ABBREVIATED PLAT AGENDA

STAFF REVIEW AND RECOMMENDATIONS
PUBLIC HEARING
MARCH 20, 2024

ABBREVIATED PLAT: MOOSE TOE
LEGAL DESCRIPTION: SEC 02, T17N, R02W, SEWARD MERIDIAN AK
PETITIONERS: FEODOR KRASKOV
SURVEYOR/ENGINEER: DENALI NORTH
ACRES: 5.39 ± PARCELS: 2
REVIEWED BY: MATTHEW GODDARD CASE #: 2024-027

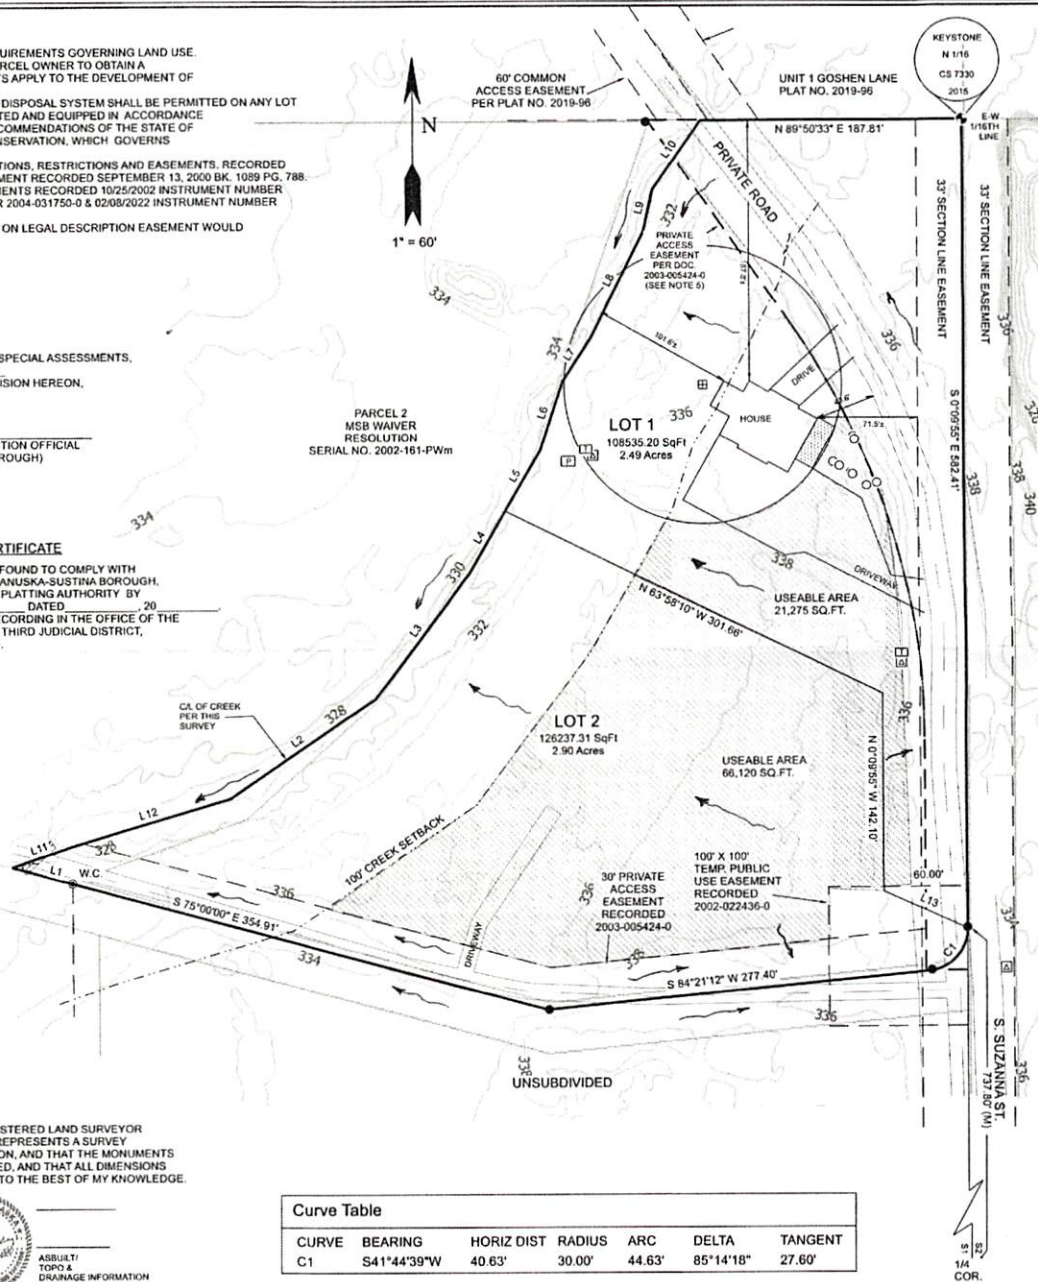
Department of Public Works (**Exhibit D**) notes that an updated test hole location map is needed (**Recommendation # 2**). The 30' private access easement should also include utilities per document 2003-005424-0. *Platting staff notes that all easements of record will be accurately shown on the final plat. Verify both lots have the minimum required frontage on the certified portions of Suzanna Street per Title 43 (Recommendation # 3).*

Provide test hole location on plan view rather than asbuilt cross section.
30' private access easement should also include utilities per document 2003-005424-0.
Verify both lots have minimum required frontage on the certified portion of Suzanna Street per Title 43.

2. Provide an updated soils report showing the test hole location.
3. Provide verification that both proposed lots meet the minimum frontage requirements onto the certified portion of N. Suzanna Street.
